Subject: CASE 13-T-0585 -Application of Cricket Valley Energy Center, LLC for a Certificate of Environmental Compatibility and Public Need Pursuant to Article VII of the Public Service Law For Approval of a New 345 kV Transmission Line From the Pleasant Valley Substation to the Cricket Valley Energy Center, LLC and the Re-Conductoring of an Existing 345 kV Line in the Town of Dover, Dutchess County.

Responses to the Department of Public Service Staff April 18, 2014
Request for Additional Information

Figure S-1
May 2014

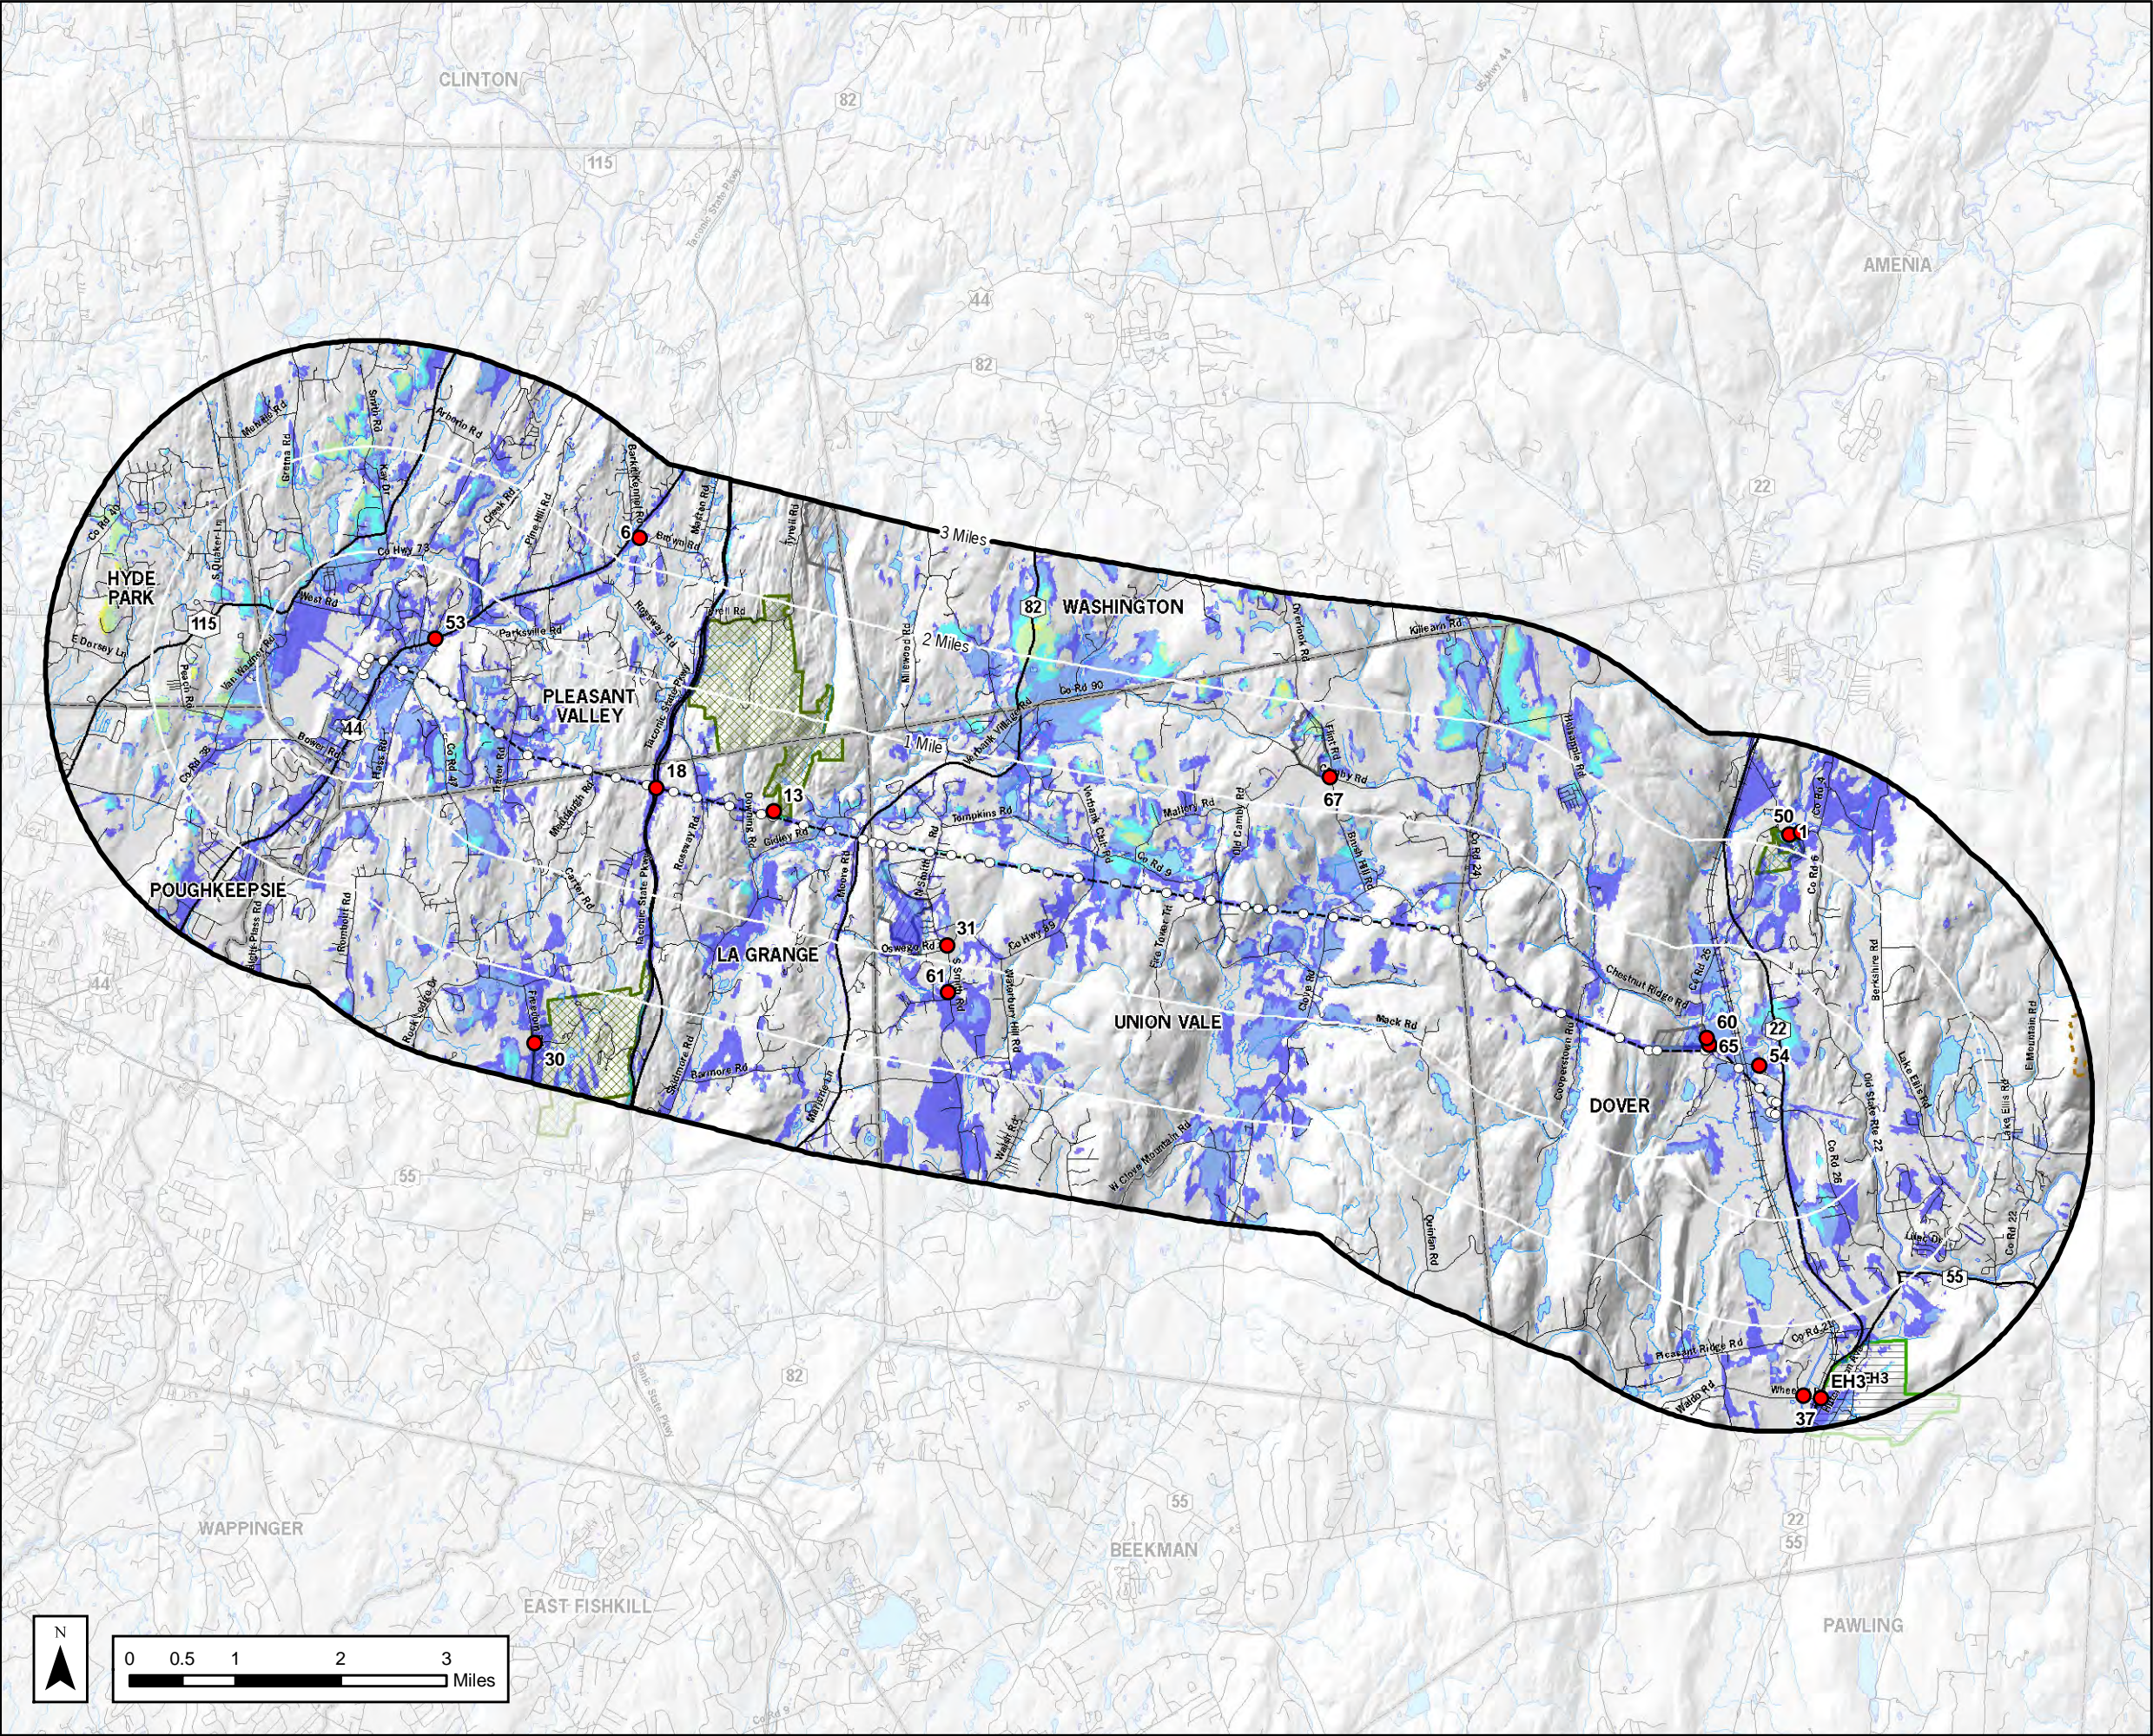
Thirteen visual resources of statewide significance and ten national register eligible historic resources were identified in the VRA. The text discussion in the VRA and Table 5 estimate the number of new utility towers that may be seen from the visual resources of statewide significance. Based on Figures A1, A2, and Table 5 the number of towers that may be visible from a scenic resource of statewide significance is between 0-18. At most locations, multiple towers maybe visible however the actual number will depend on the screening provided by vegetation as stated on page 37. To show that the new power line has been located to minimize visual impacts, additional existing condition photographs from selected scenic resources of statewide significance are necessary. These photographs should demonstrate the visibility of the existing power line, which is an accurate baseline for the future conditions. The VRA has included photographic simulation that emphasizes the near view images and there are five existing condition photographs in the report, which is not adequate to build a general understanding of the visual setting. Including additional photographs from statewide visual resources will fill out the VRA. The applicant should submit additional photographs or identify locations where photographs can be taken to complete the VRA.

Response to #3: Attachment B to this letter includes a photographic layout, key map to photo locations, and a description of means and methods prepared by Saratoga Associates, Inc. to address the Commission's requests.
